WESLEY STATION SUBDIVISION

APPLICATION NUMBER 6 DATE December 7, 2006
APPLICANT Wesley Station Subdivision
REQUEST Subdivision

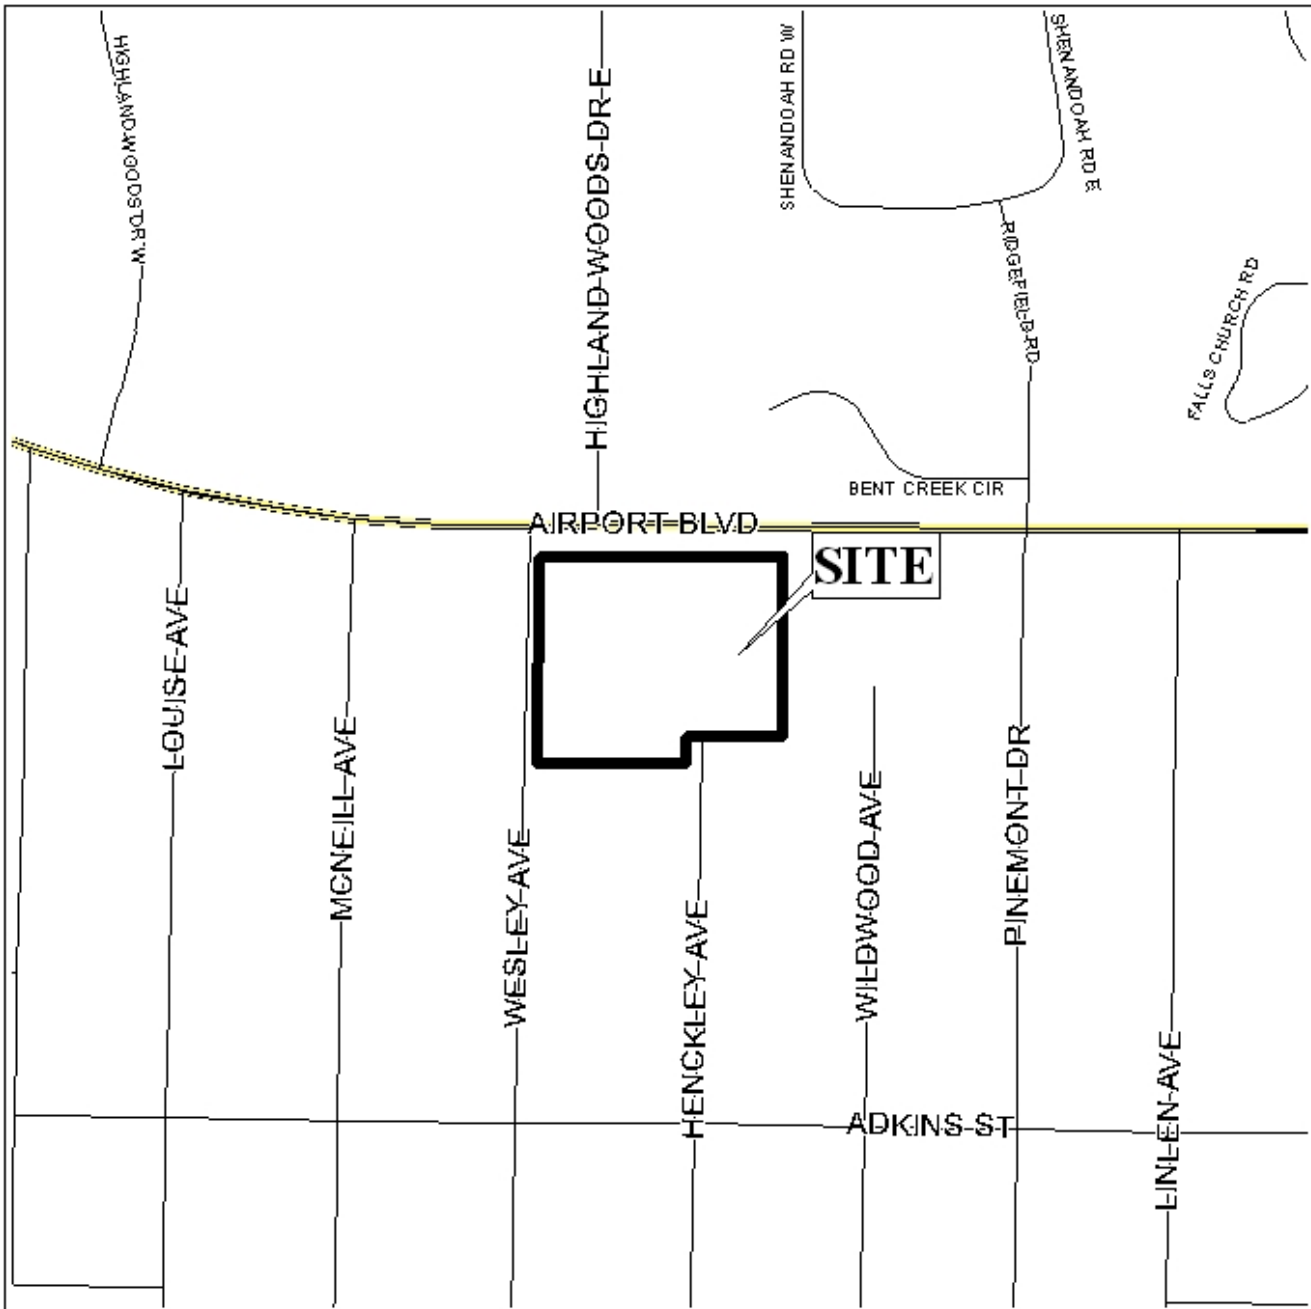
The preliminary plat for the current subdivision depicts the previously required 50' "no building/drive buffer," a 35' vegetative buffer from the terminus of Henckley Avenue to the East

property line, as well as a 10' vegetative buffer along the East property line (there is no indication on the plat as to the provision of a wooden fence). The modified turn-around of item 5 is depicted on the plat. There are also notes on the preliminary plat addressing items 2, 4 and 6.

The vacation process has been initiated, however, the process has not been completed. As previously required, the vacation process must be completed prior to signing the final plat, if approved.

As the site is fronts Airport Boulevard, a major street, and two minor streets (Wesley and Henckley Avenue), access management is a concern. A note should be place on the final plat, if approved, stating that lot 1 is limited to one curb-cut onto Airport Boulevard and one curb-cut onto Wesley Avenue, that lot 2 is limited to one curb-cut onto Airport Boulevard and denied access to Henckley Avenue, and that the size, design and location of all curb-cuts are to be approved by the Planning Section of Urban Development and Traffic Engineering, and comply with AASHTO standards.

Based on the preceding, the plat is recommended for Tentative Approval, subject to the following conditions: 1) the provision of an eight-foot wooden privacy fence and vegetative buffer where the site adjoins residential zoning; 2) placement of a note on the final plat stating that no structures, parking or driveway(s) may be constructed within the southern 50' (between Wesley Avenue and Henckley Avenue [to be vacated]); 3) compliance with Engineering comments (*Land disturbance application required for required relocation of drainage structures, in approved applicable easements. After relocation of drainage structures is complete, the vacation of rights-of-way will be applied for. Upon vacation of the right-of-way, another land disturbance application will be made for the construction of a City Engineering approved cul-de-sac. In future development, detention will be required on-site. Must comply with all storm water and flood control ordinances. Any work performed in the right of way will require a right of way permit.*); 4) completion of the vacation process prior to the recording of the final plat; 5) placement of a note on the final plat stating that lot 1 is limited to one curb-cut onto Airport Boulevard and one curb-cut onto Wesley Avenue, that lot 2 is limited to one curb-cut onto Airport Boulevard and denied access to Henckley Avenue, and that the size, design and location of all curb-cuts are to be approved by the Planning Section of Urban Development and Traffic Engineering, and comply with AASHTO standards; 6) the provision of a modified turnaround at the northern terminus of Henckley Avenue; 7) placement of a note on the final plat stating that access to Henckley Avenue is denied; and 8) full compliance with all other municipal codes and ordinances.
